<b>SUNDRY NOTICES AND REPORTS ON WELLS</b> (DO NOT USE THIS FORM FOR PROPOSALS TO DRILL OR DEEPEN OR PLUG BACK TO A DIFFERENT RESERVIOR. USE "APPLICATION FOR PERMIT" (FORM C-101) FOR SUCH PROPOSALS.)		WELL API NO. <b>30.015.02606</b>

2. Name of Operator <b>Apache Corporation</b>		6. State Oil & Gas Lease No.
3. Address of Operator <b>303 Veterans Airpark Lane, Ste. 3000, Midland, TX 79705</b>		7. Lease Name or Unit Agreement Name <b>Emmpire Abo Unit (309164)</b>

**Apache Corporation proposes to P&A the above mentioned well by the attached procedure. A closed loop system will be used for all fluids from this wellbore and disposed of required by OCD Rule 19.15.17.14 NMAC.**

**SEE CHANGES TO PROCEDURE**

## PROPOSED PROCEDURE

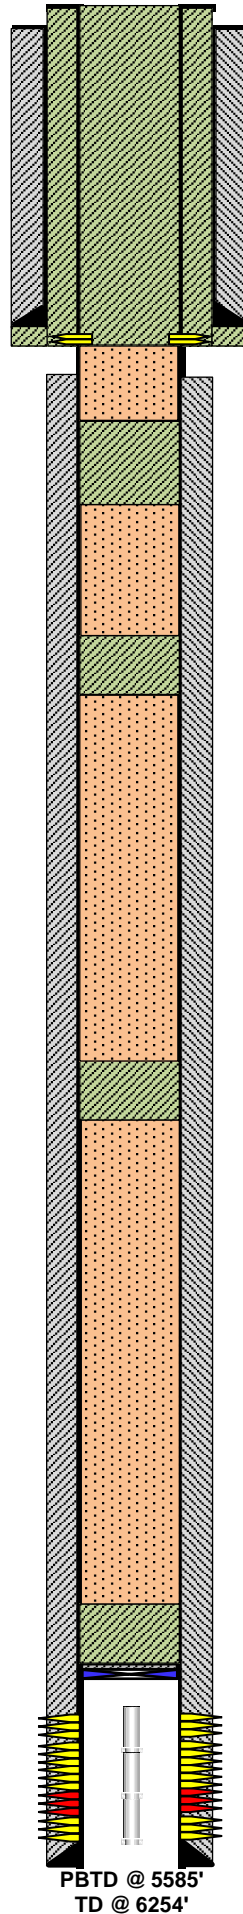
**\*\*\*\*SEE ATTACHED COA's\*\*\*\***

5. PUH & perf @ 805' & sqz 230 sx Class "C" cmt from 805' to surf. (Surf Shoe, Water Board, & Surf Plug)

4. PUH & spot 30 sx Class "C" cmt from 1472'-1185', (Grayburg & Queen) **WOC & Tag**

3. PUH & spot 25 sx Class "C" cmt from 2070'-1870', WOC/TAG (San Andres)

2. PUH & spot 25 sx Class "C" cmt from 3605'-3405', (Yeso) **WOC & Tag**

1. MIRU P&A rig. RIH w/ tbg & verify CIBP @ 5585', CIRC w/MLF & spot 25 sx Class "C" cmt from 5585'-5385', (CIBP over Abo) **WOC & Tag**
